MONTALVO ELEMENTARY SCHOOL HVAC REPLACEMENT

BID # E2-24

ADDENDUM #01

ADDENDUM NUMBER ONE

PANEL F
A-Series® Panelboard
AB433

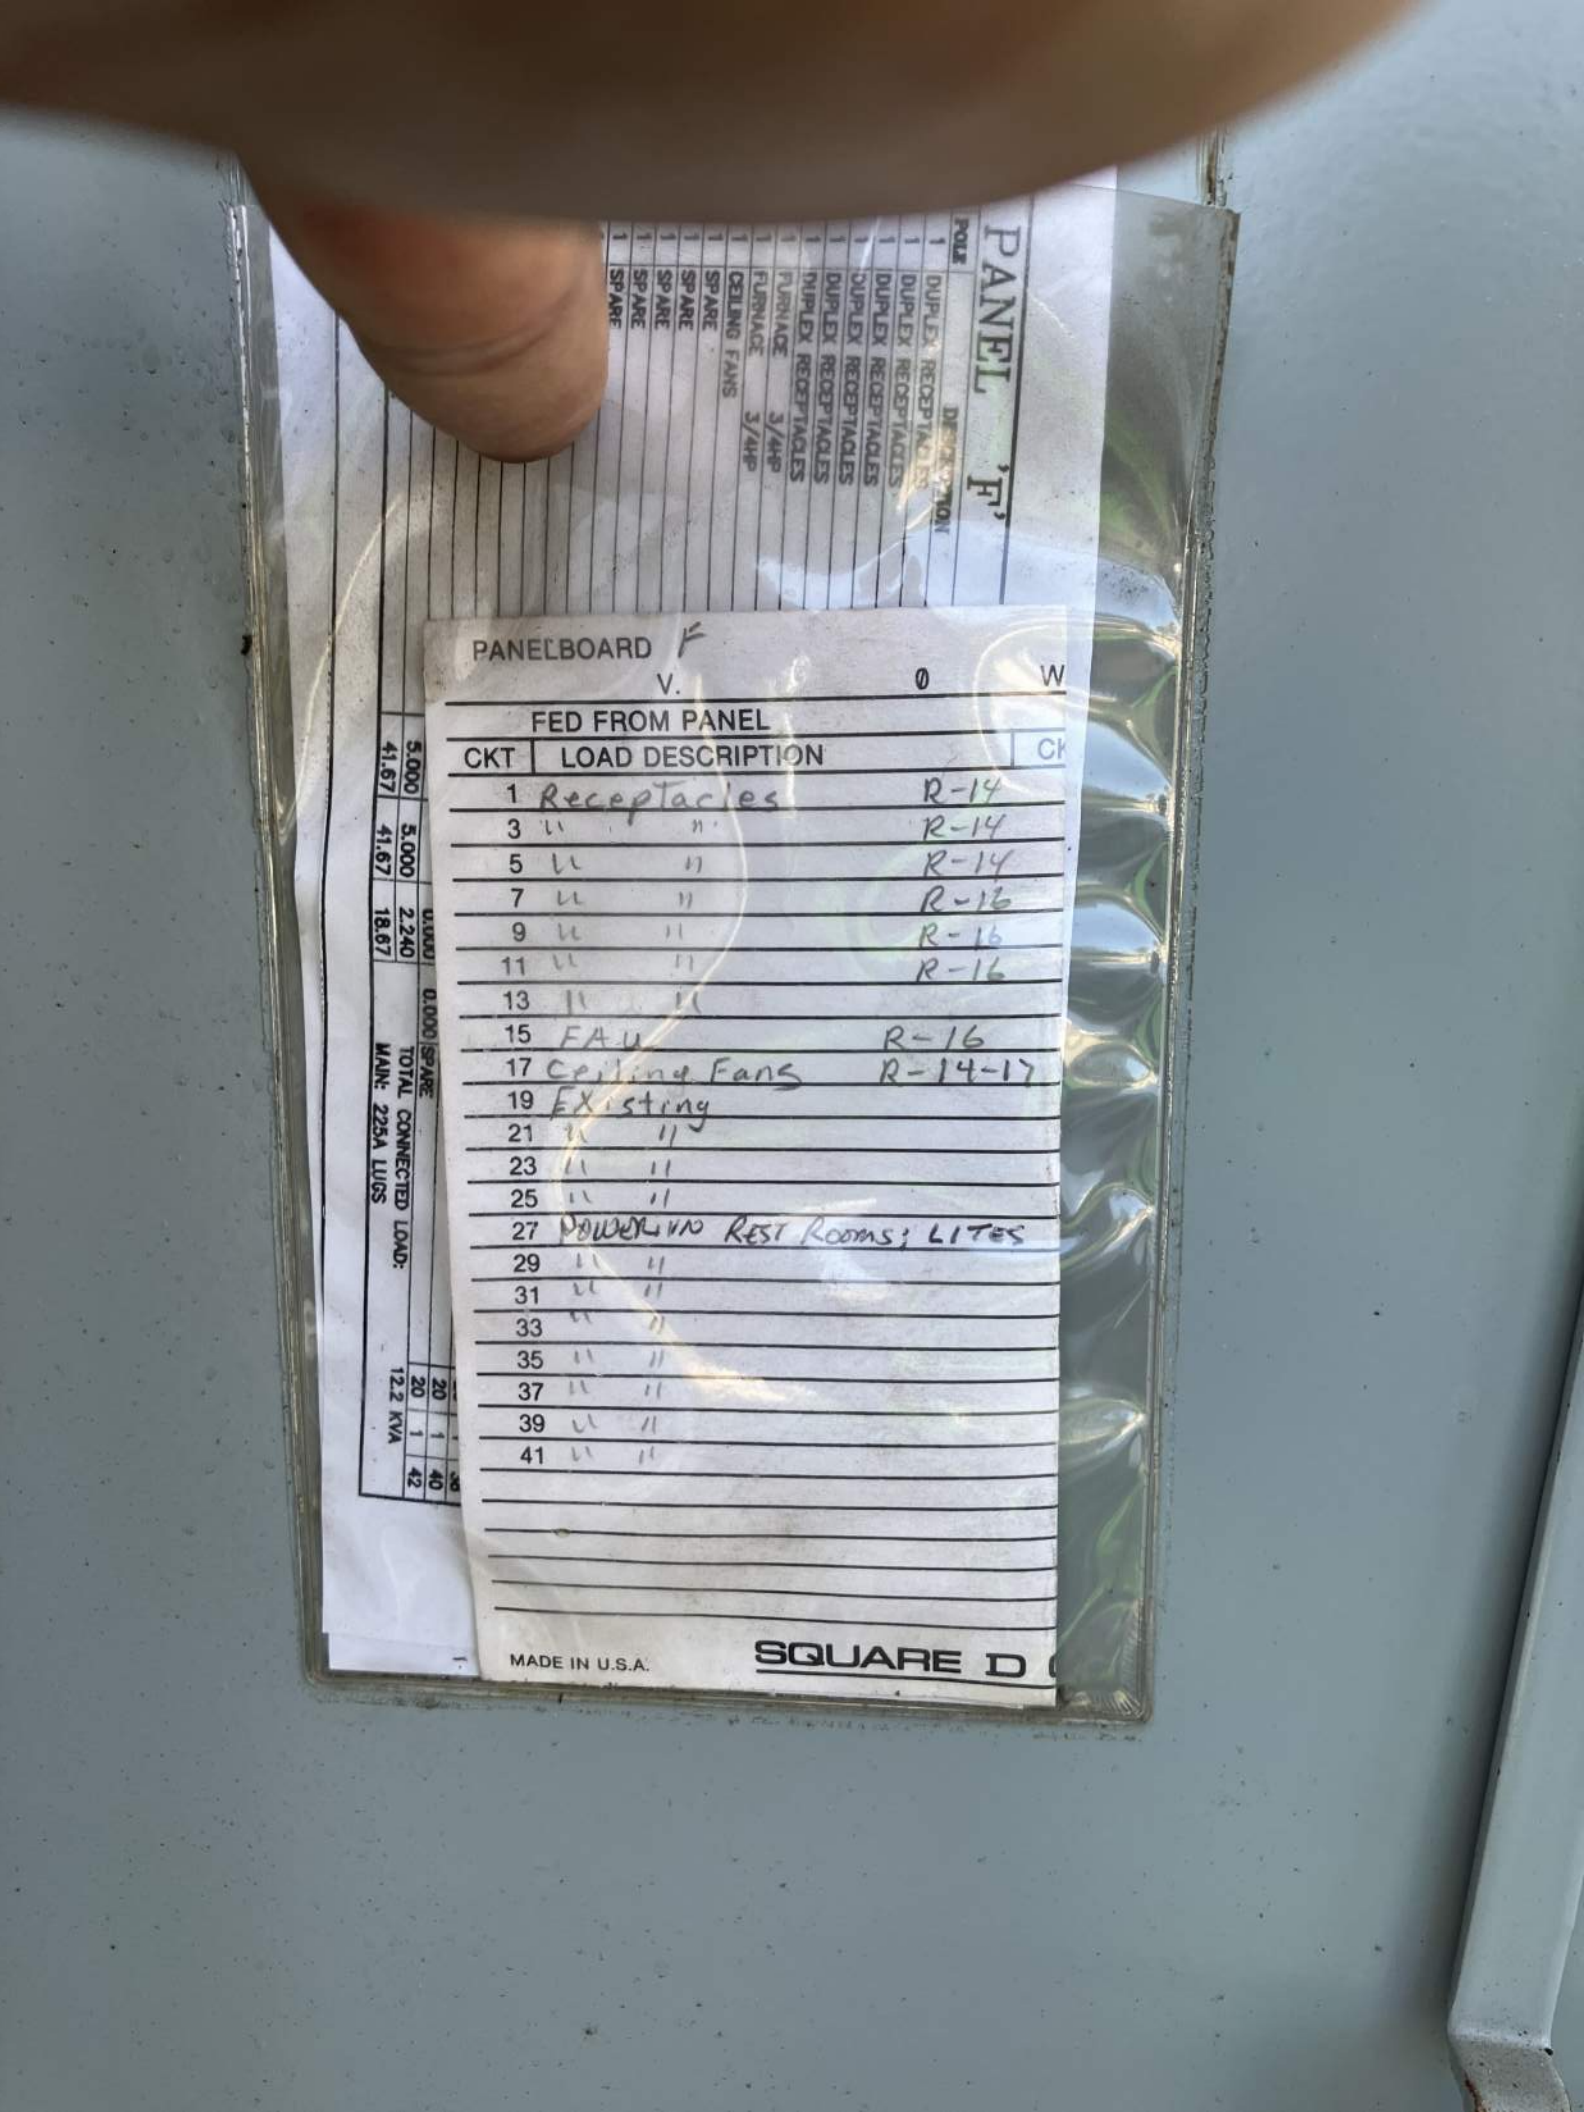
Q5: Please share photos of the main switchboard for reference.

A5: Photos of Switchgear are attached.

SHEET A-600 1

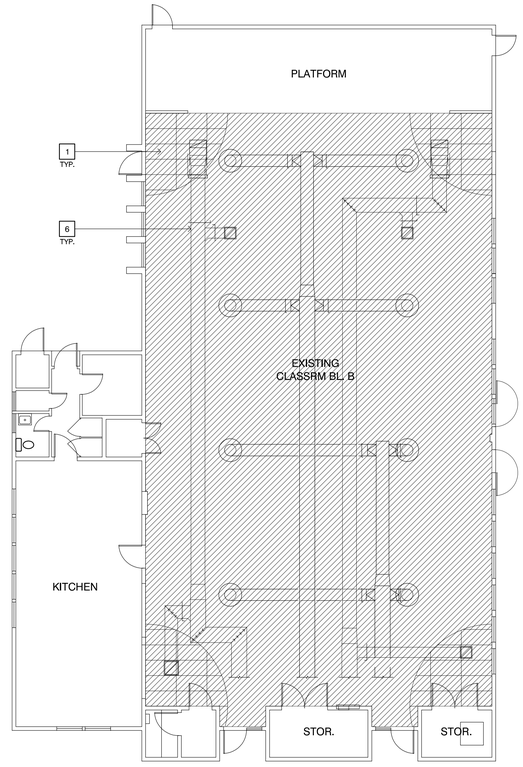
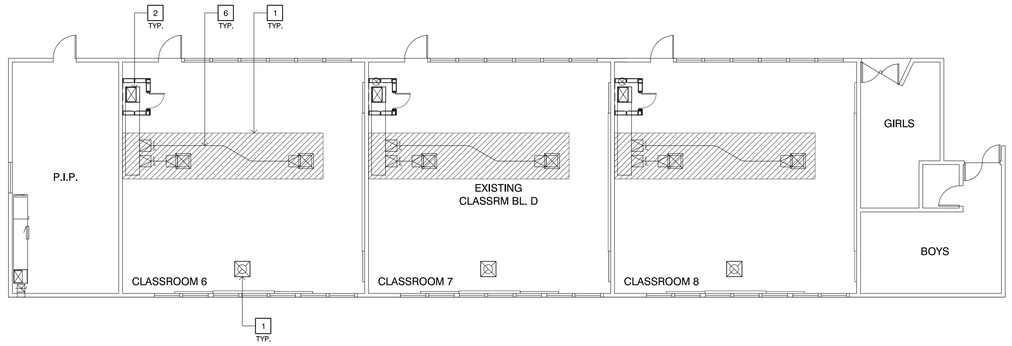
Insert two new drawing sheets A-600 and A-601 to the bid plans. These new reflected ceiling plans indicate extent of planned ceiling modifications and replacements.

SHEET E200

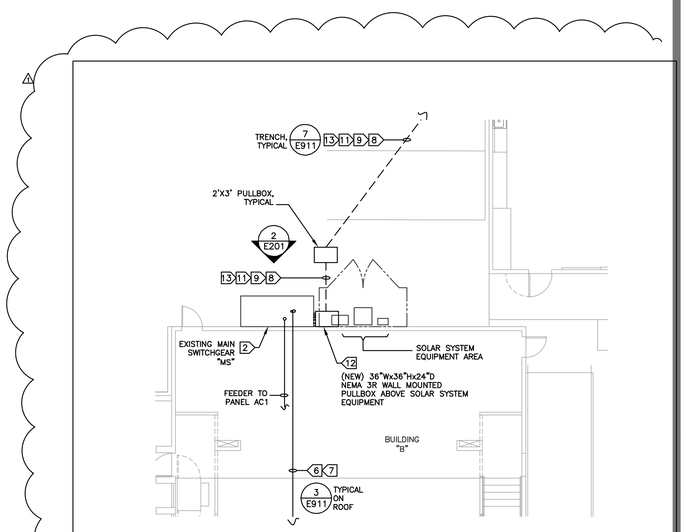
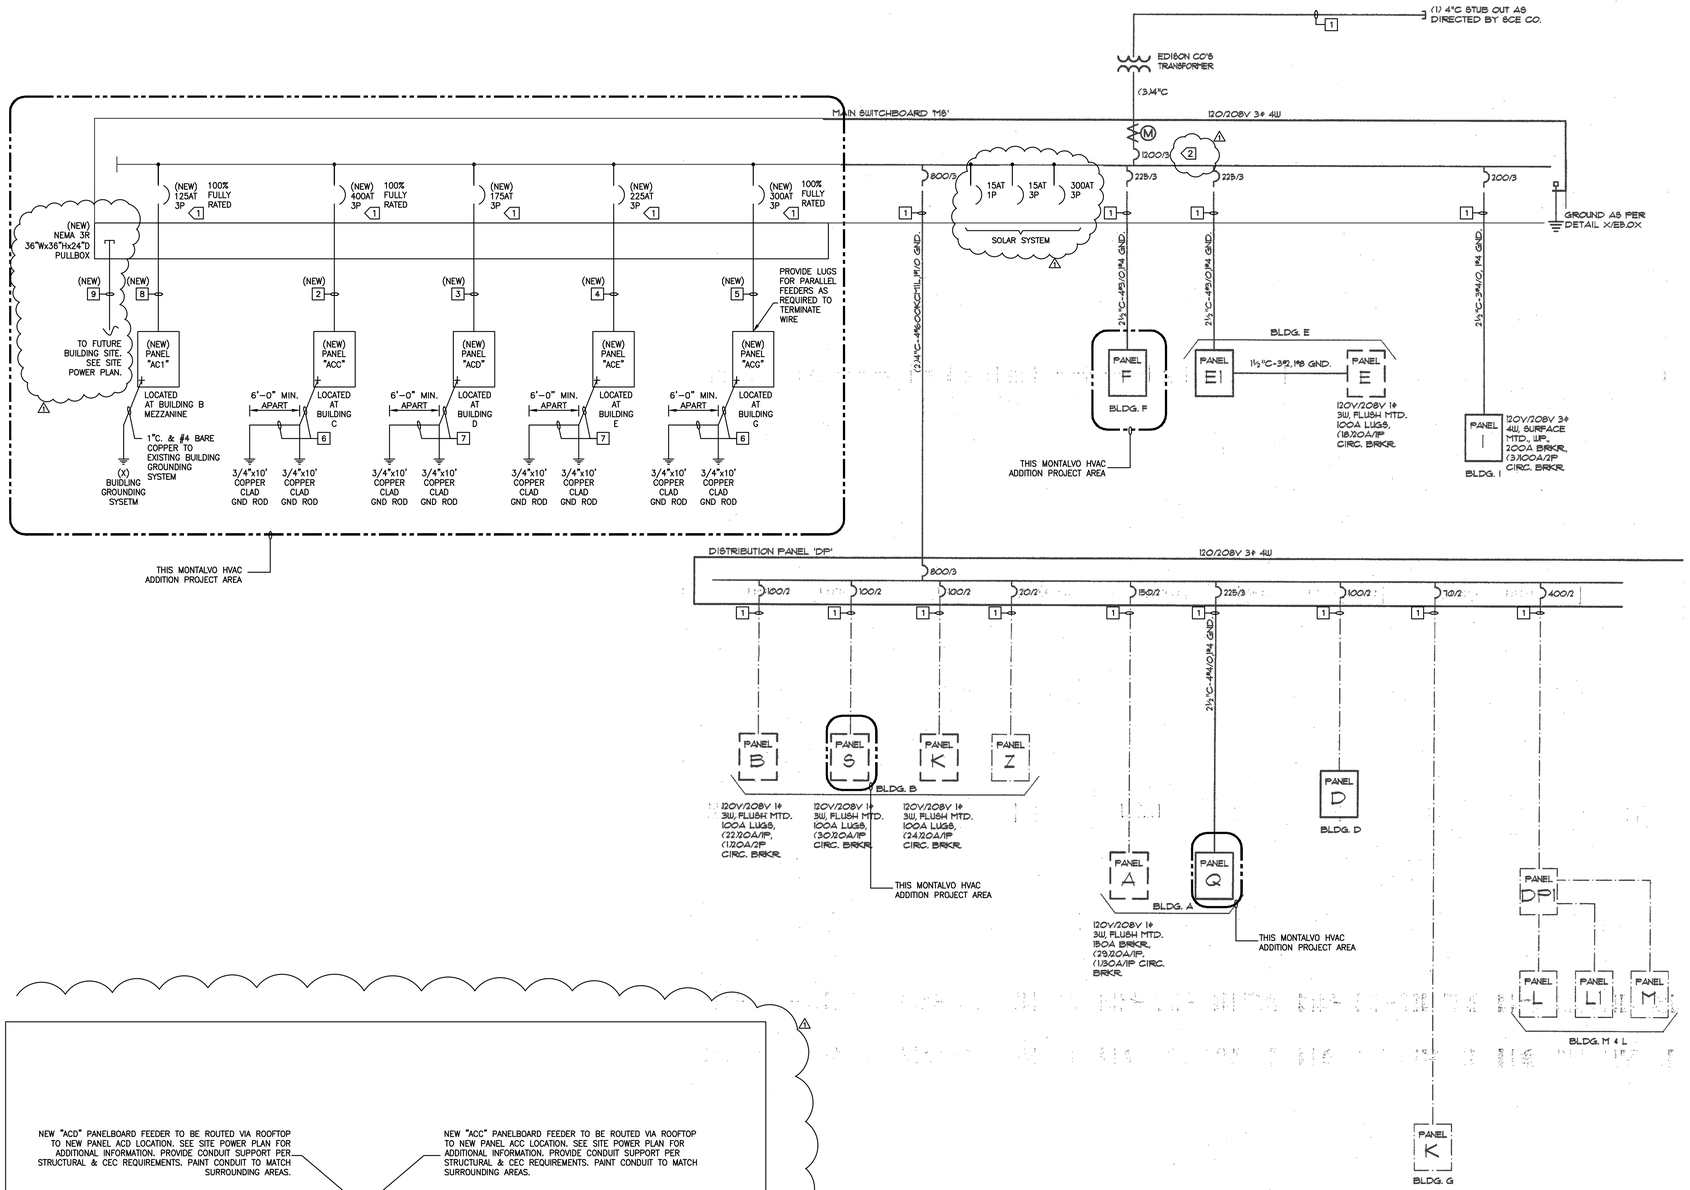
Relocation new wall mounted pull box as shown in revised sheet E-200 and E-201 due to intervening solar project equipment installation.

Add (2) 2-1/2" conduits from switchgear to future project location, to fall in same trench as one serving the feed to the Kindergarten building. See revised E-200 and E-201, attached.

12. PROVIDE WALL MOUNTED PULLBOX ADJACENT TO MAIN CAMPUS SWITCHBOARD "MS" FOR NEW PANELBOARD FEEDERS ACE, ACG, & (2)2-1/2"C.O. SPARES. SEE SINGLE LINE DIAGRAM FOR FEEDER INFORMATION. PAINT TO MATCH SURROUNDING AREA. PROVIDE CLOSE NIPPLE CONDUITS INTO SWITCHGEAR ENCLOSURE AS REQUIRED.

13. FROM "MS" CONTRACTOR SHALL SAW CUT, TRENCH, & PROVIDE (2)2-1/2"C.O. SPARES TO PULLBOX SOUTH OF BASKETBALL COURT FOR FUTURE BUILDING SITE.

SHEET
E402

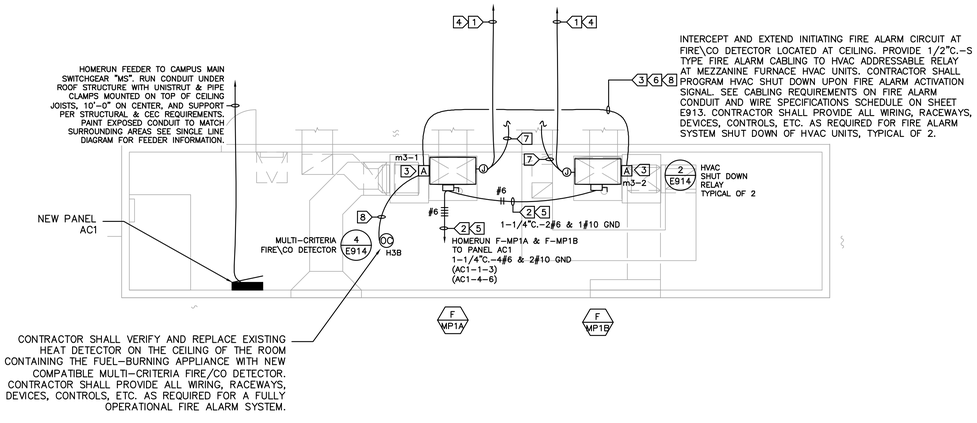
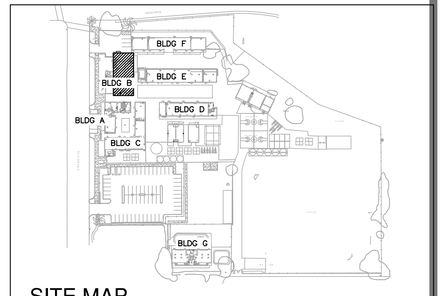
Information has been added to clarify the routing of the feeder between MS and panel AC1 in Building B. See revised E-402, attached.
